**The W Nursing School
Neshoba General
Philadelphia, MS**

Addendum No. 4

June 15, 2026

This addendum forms a part of the contract documents and modifies the original plans and specifications dated June 4, 2026.

1 LEVEL 01 SITE DRAINAGE PLAN
1/8" = 1'-0"

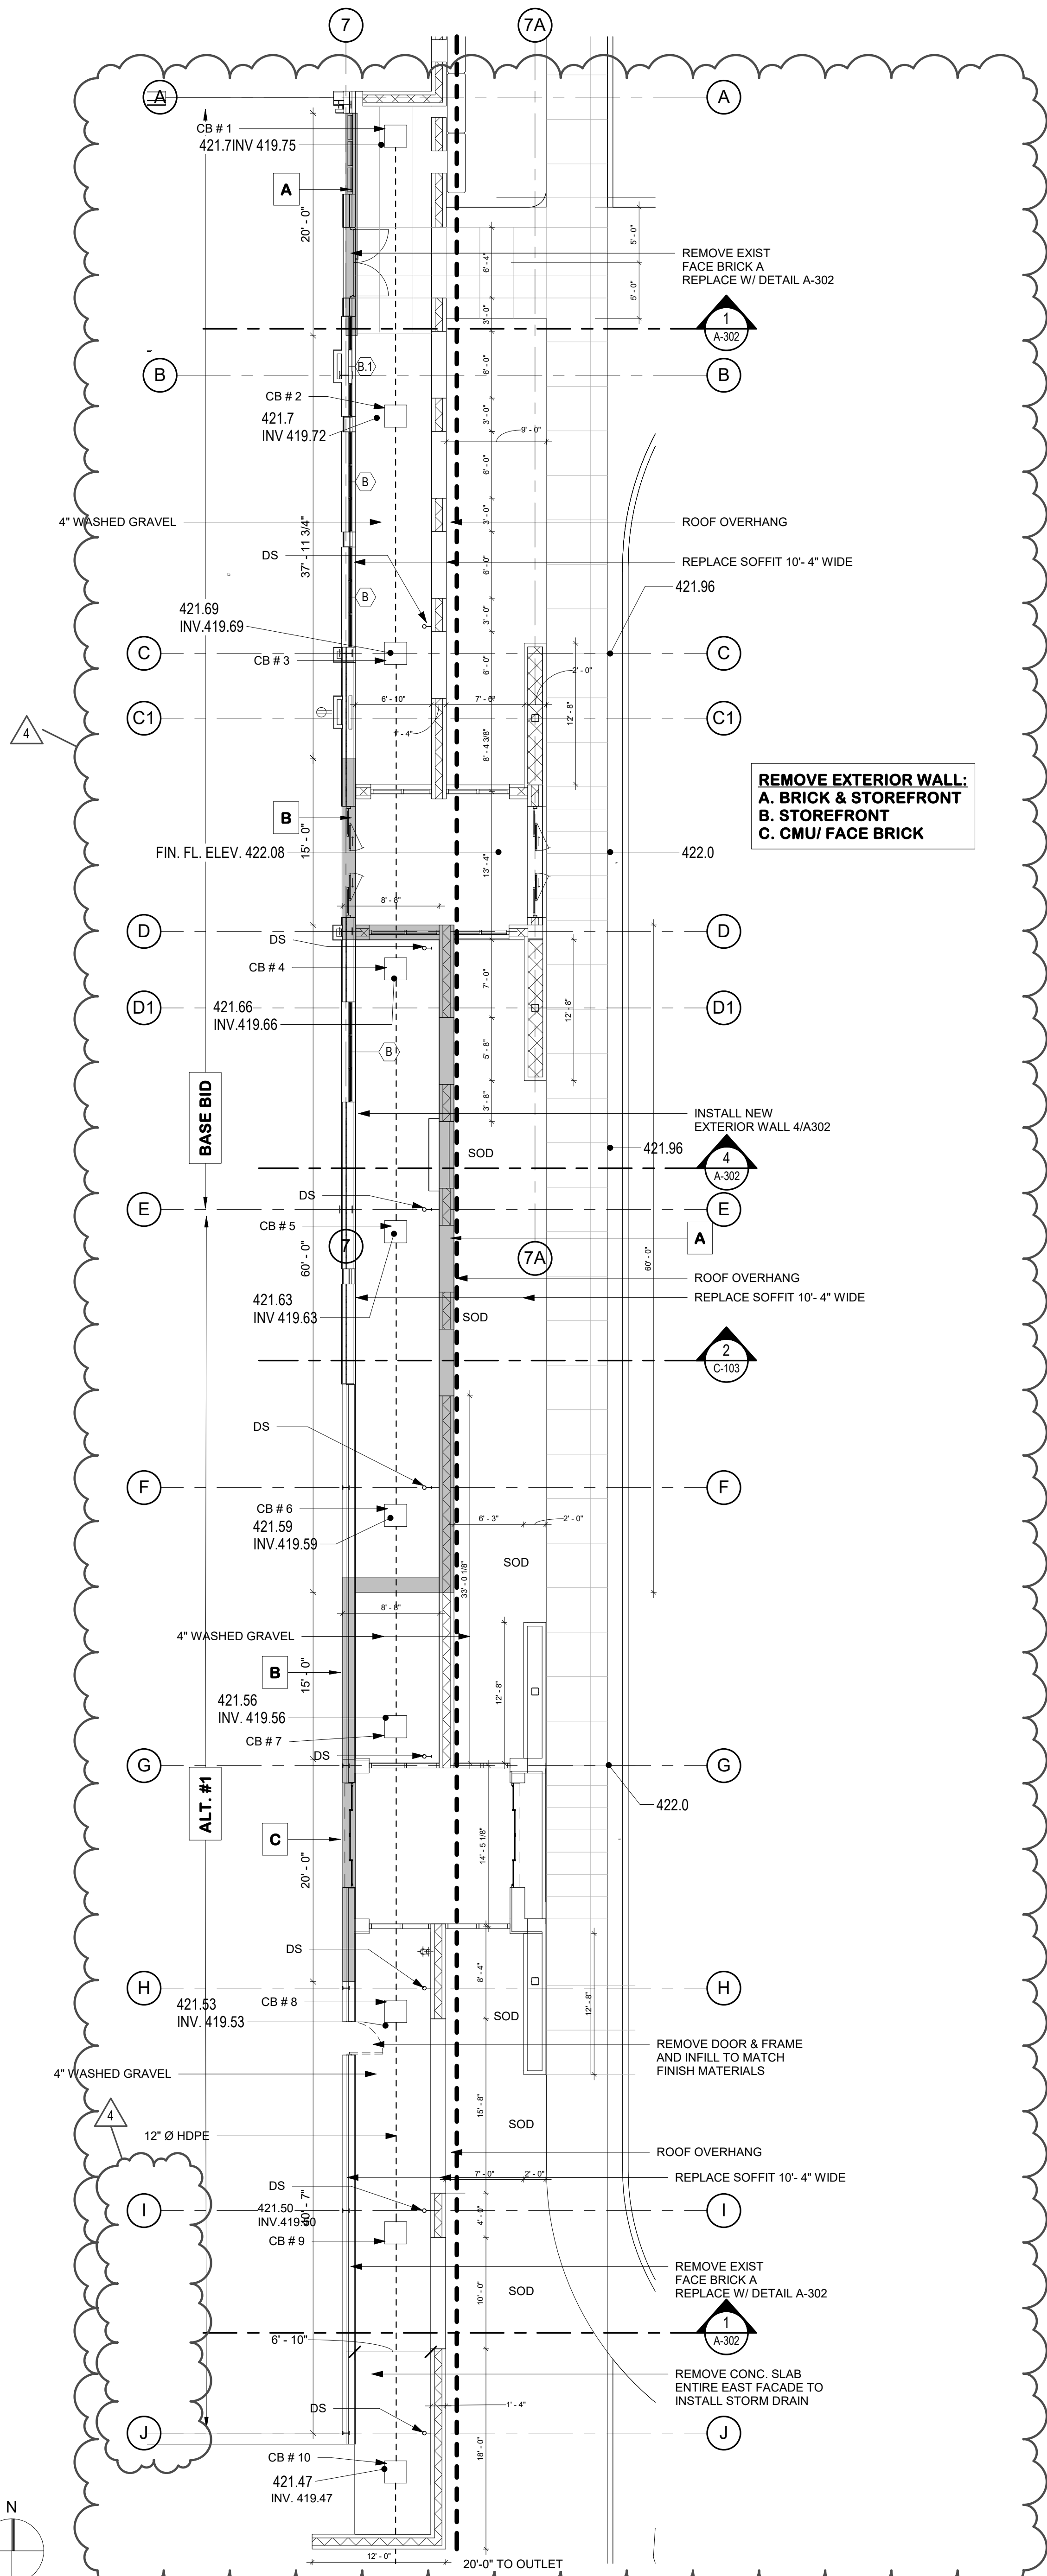
Note: Detail No. 1 indicated the scope of work to the east façade and the catch basin numbering.
Detail No. 2 includes the soffit detail at the east façade.

1 BUILDING ELEVATION NORTH
1/8" = 1'-0"

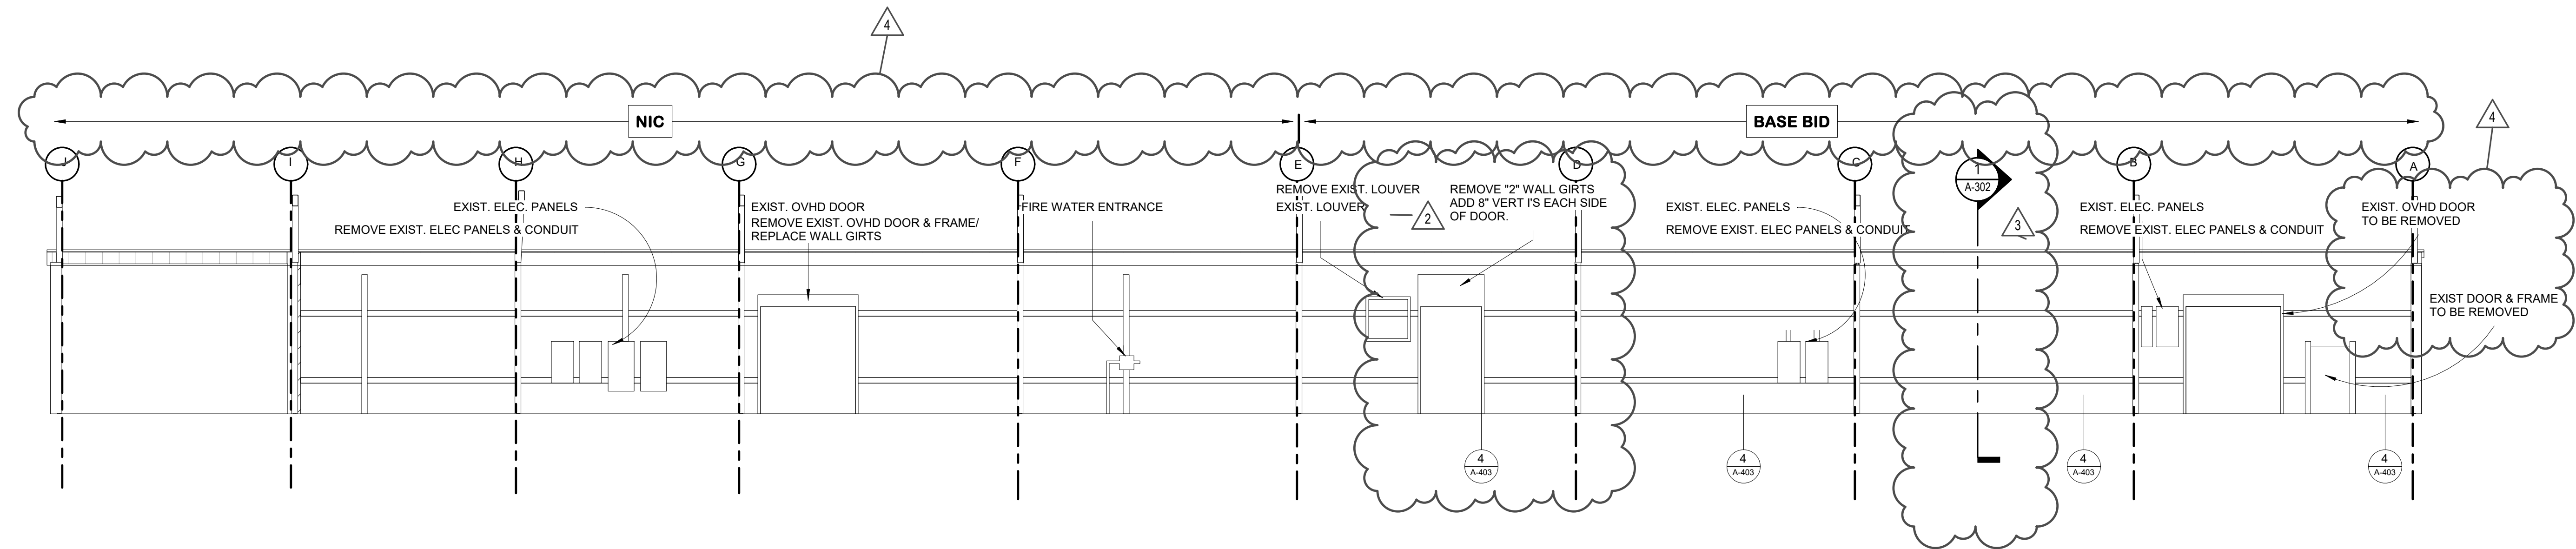
Note: Detail No. 1 clarifies the scope of work for removing the existing framing system to allow for new windows and storefront
Detail No. 2 clarifies the scope of work for removing the two existing door openings between column lines A and B.

2 EXISTING. BUILDING INTERIOR ELEVATION- WEST
1/8" = 1'-0"

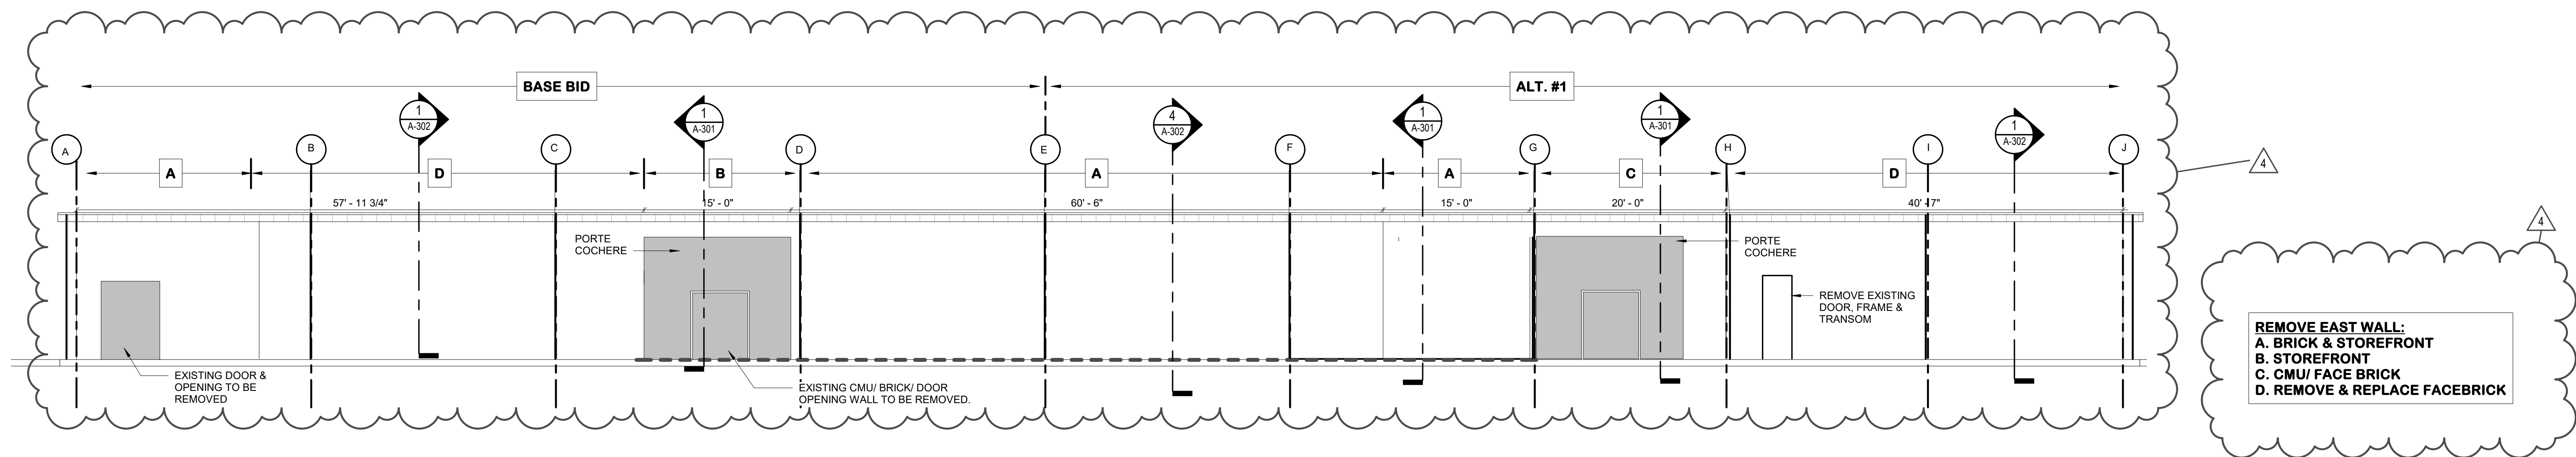
Note: Detail No. 2 clarifies the west façade as "Base Bid".
Detail No. 3 clarifies the scope of work along the east façade.

1 NORTH ELEVATION
1/8" = 1'-0"

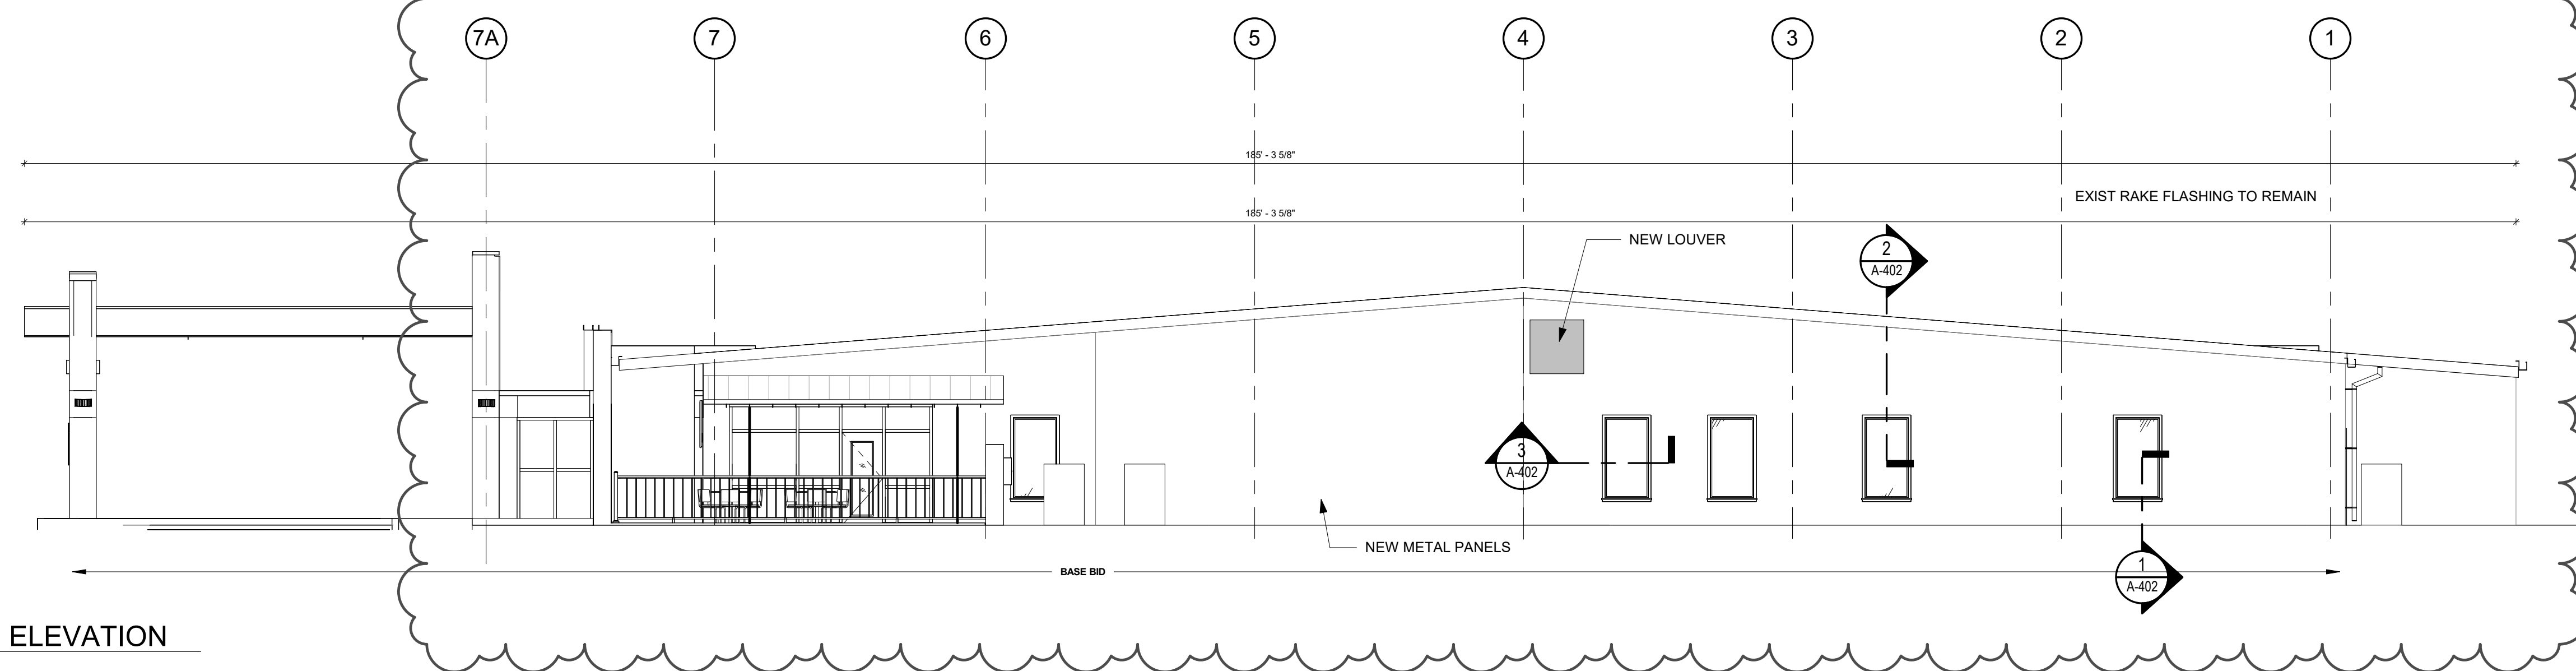
Note: Detail No. 1 clarifies the “rake” flashing to remain.
Detail No. 3 clarifies the “Base Bid” and “Alternate No 1” at east façade.
Detail No. 4 clarifies the scope of work required at west façade “Base Bid”.

1 WALL SECTION - EAST WALL
1" = 1'-0"

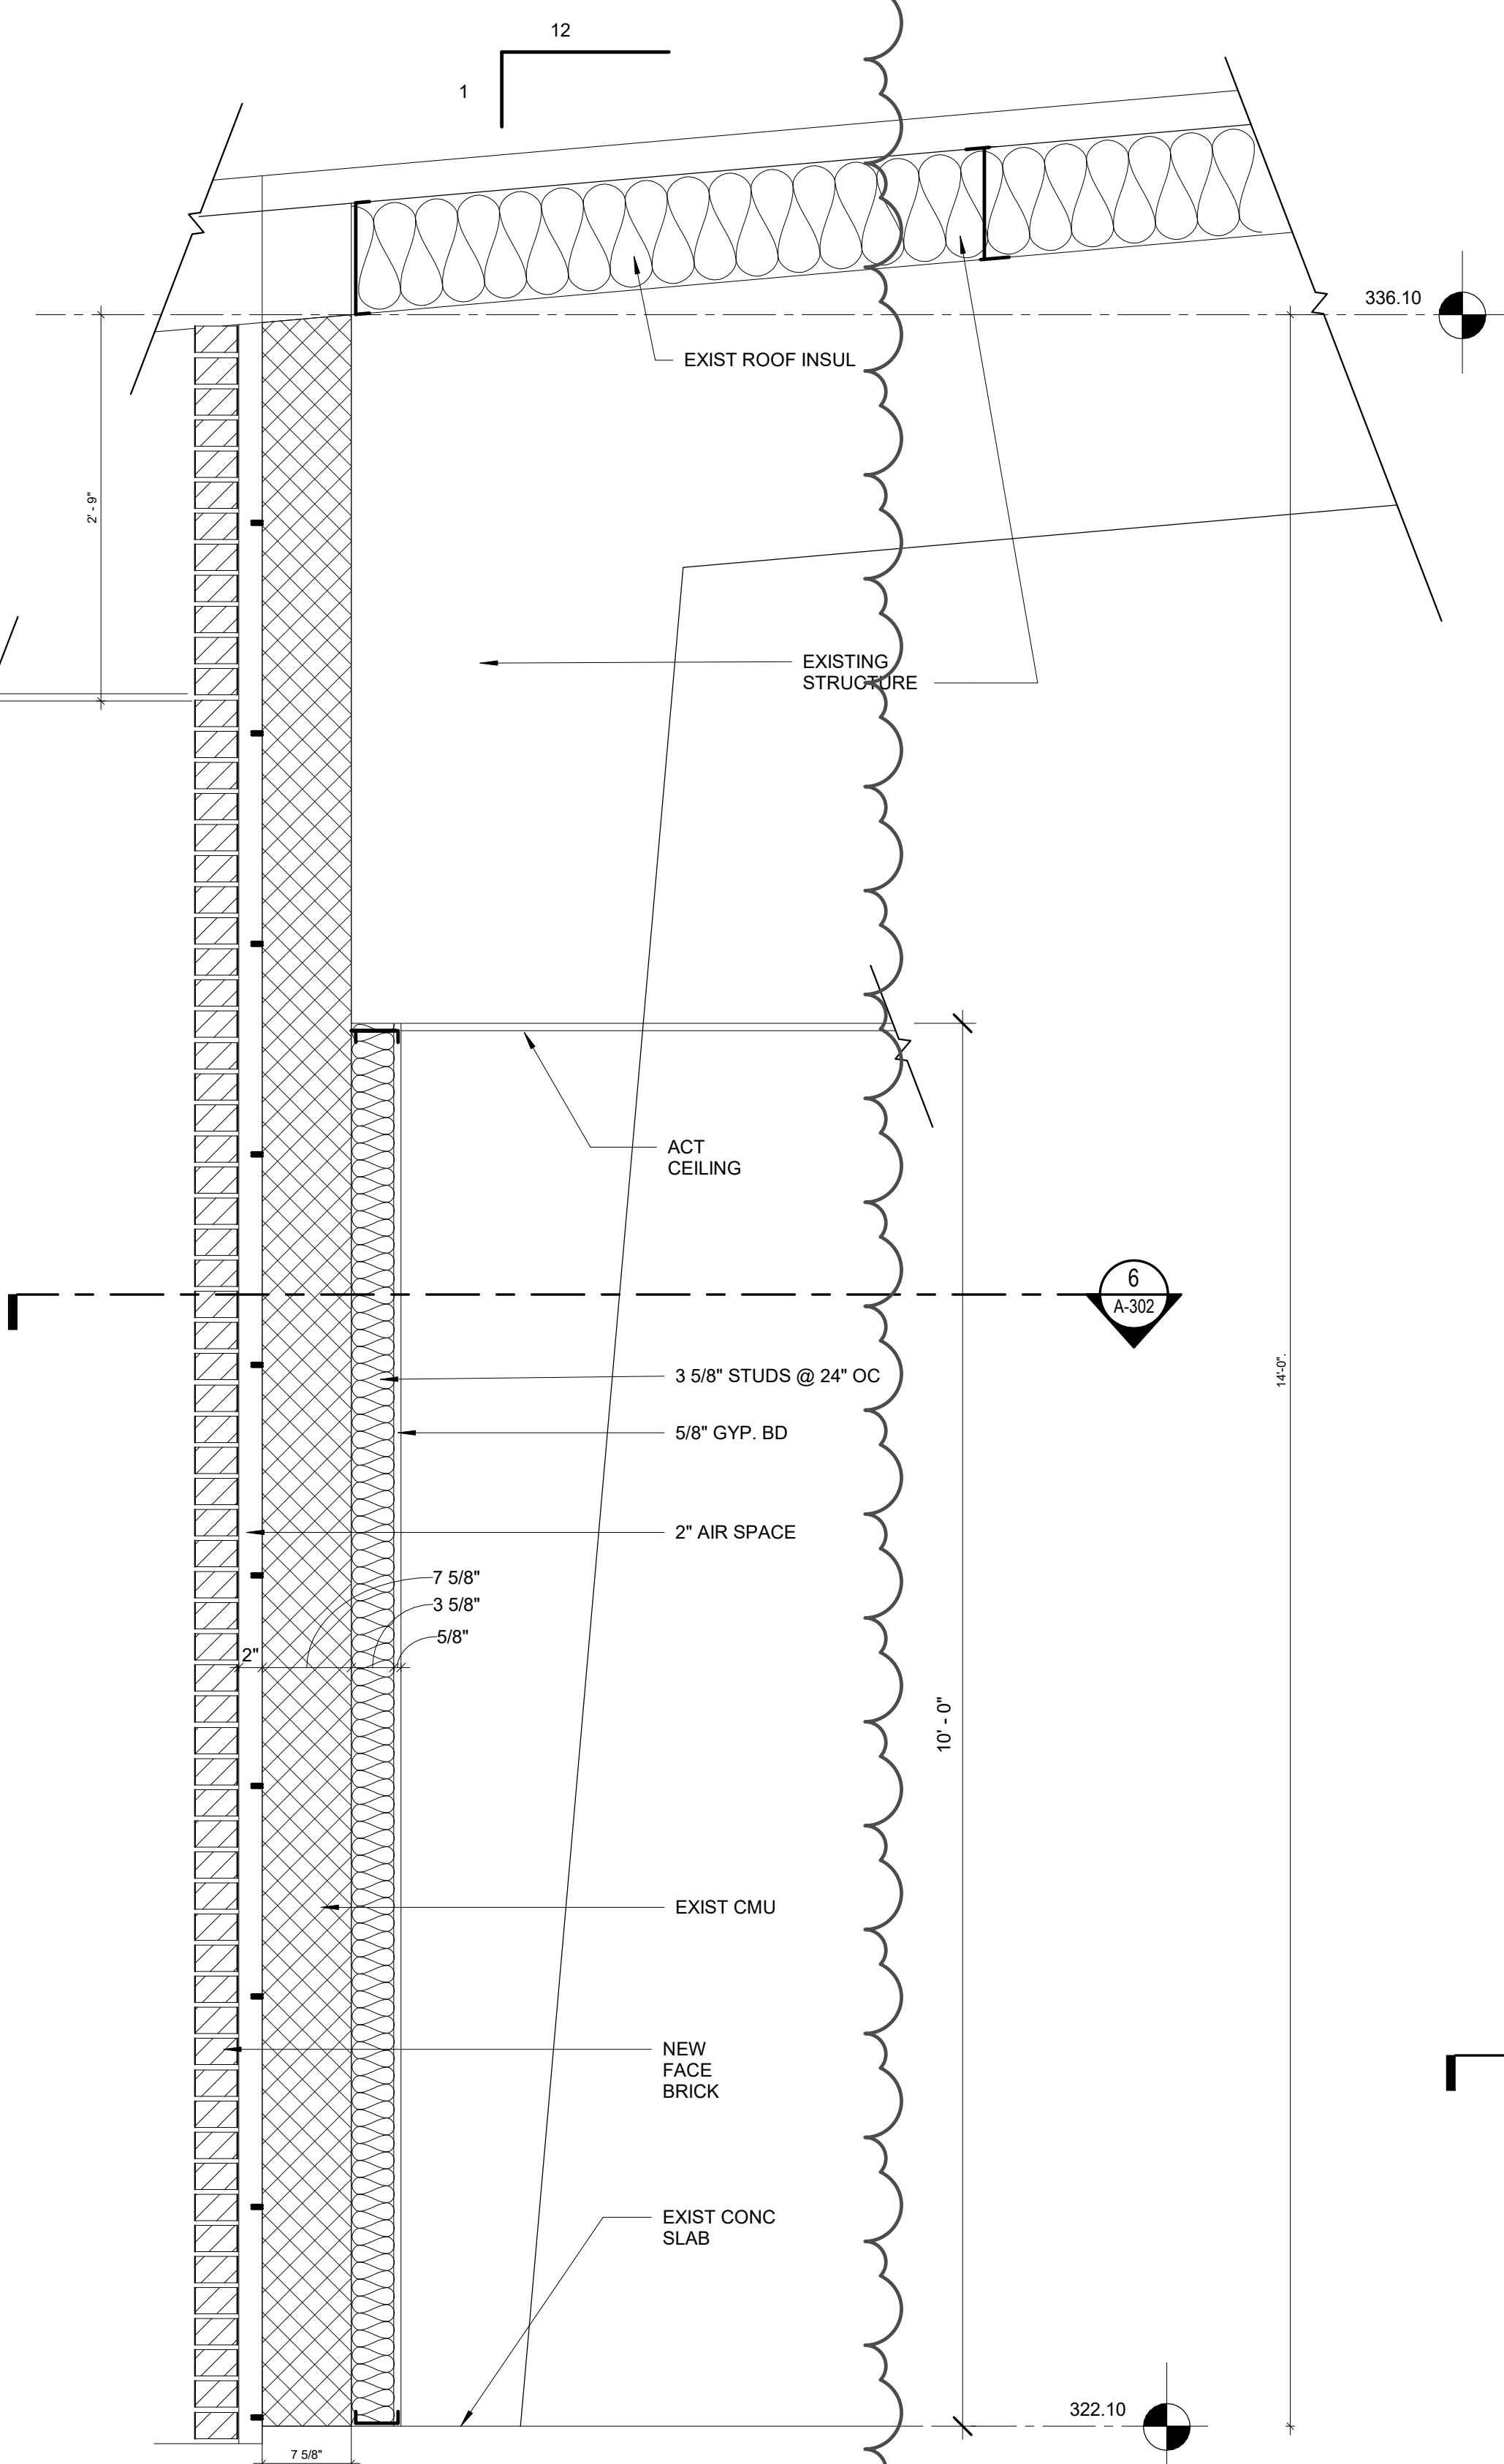
Note: Detail No. 1 clarifies new face brick at existing CMU exterior wall at east façade.
Detail No. 2 indicates new 6” stud wall with face brick at east wall between column lines G and H.
